CITY OF KELOWNA

MEMORANDUM

Date: October 25, 2022
File No.: Z22-0063
To: Planning and Development Officer (MT)
From: Development Engineering Manager (NC)
Subject: Dougall Rd N 285, 305 McIntosh Rd 365

UC4 to UC4R

1 SITE PLAN
 DP1.03 SCALE: 1:150

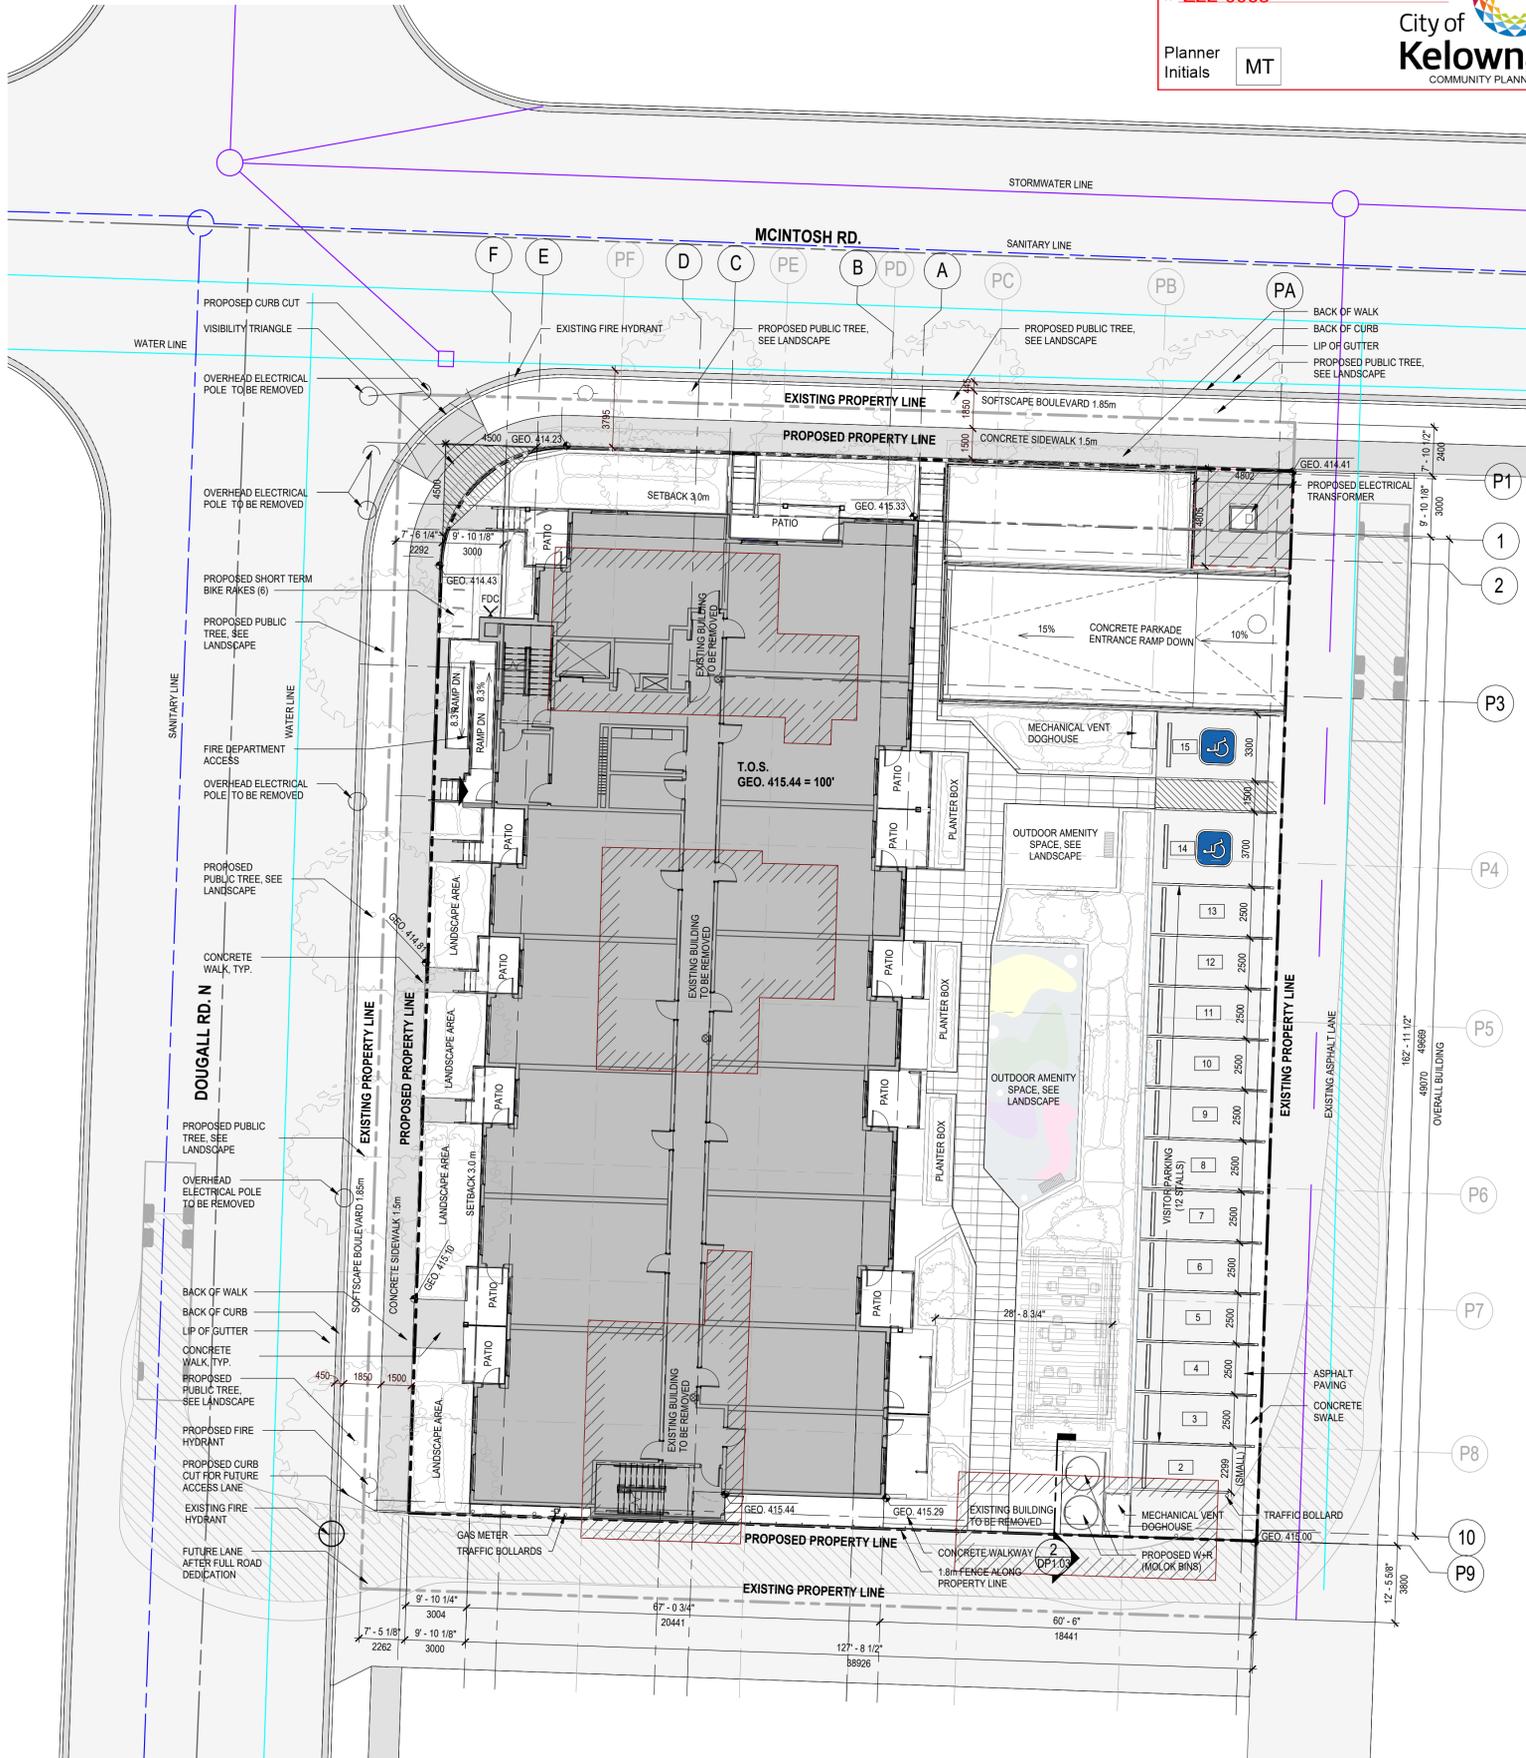
- a. Approximately 2.5m dedication along the McIntosh Rd frontage is required to achieve a ROW width of 20.0m.
- b. Approximately 2.5m dedication along the entire frontage of Dougall Rd N is required to achieve a ROW width of 20.0m.

- c. Dedication of 3.8m is required along the south property line of 285 Dougall Rd N for half of a future urban center lane with ROW width of 7.6m.
- d. A corner cut of 285 Dougall Rd N south east property corner, at the intersection between lanes, will be required. Dimensions of the corner cut are to be determined by the Developer's consulting civil engineer and confirmed through submission of turning movements and sightline analysis for the intersection.

- e. Existing driveways on McIntosh Rd and Dougall Rd must be removed and all access to the development must be provided off the Lane.
- f. Indicate on the site, the locations of loading bays as well as garbage and recycle bins. Provide turning movements for a HSU vehicle to confirm manoeuvrability of garbage collection without requiring reverse movement onto McIntosh Rd or Dougall Rd N. Garbage pickup from street is not permitted.
